**PREVOST**

**WARRANTY  
BULLETIN**

**WB14-45C**

DATE :	OCTOBER 2014	SECTION :	06 - Electrical
EXPIRATION:	OCTOBER 2016		
SUBJECT :	R49 "ACM RELAY" REMOVAL

Figure 3 : H-series vehicles

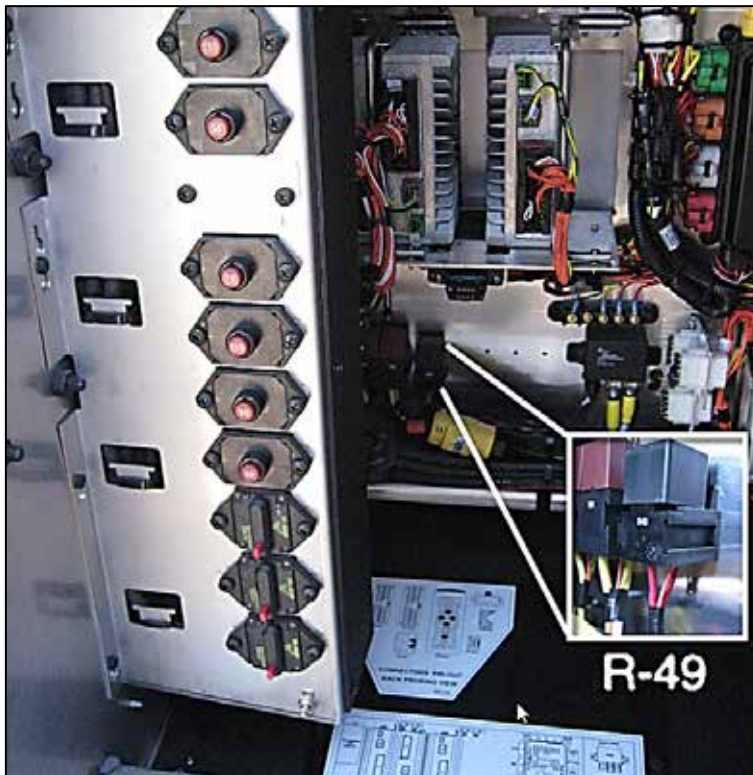
**2. Locate R49 relay.**

On *H series* vehicles, relay is located on the lower left section of the rear wall. (Fig. 3)

On *X series* vehicles, remove the vertical cover of the electrical compartment above the battery compartment.

Relay is located in the upper left corner of the electrical compartment. (Fig. 4)

### 3. Remove relay.

Disconnect wires and remove base.

Figure 6 : Decal 068891I

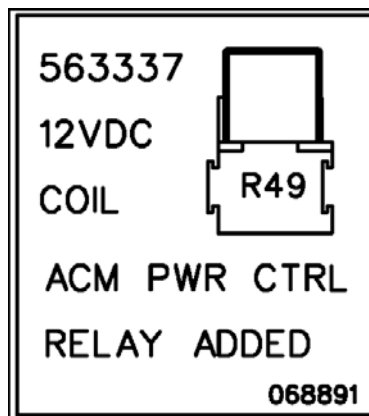
### 4. Decal Removal

Remove decal "ACM PWR RELAY ADDED" on compartment main decal.
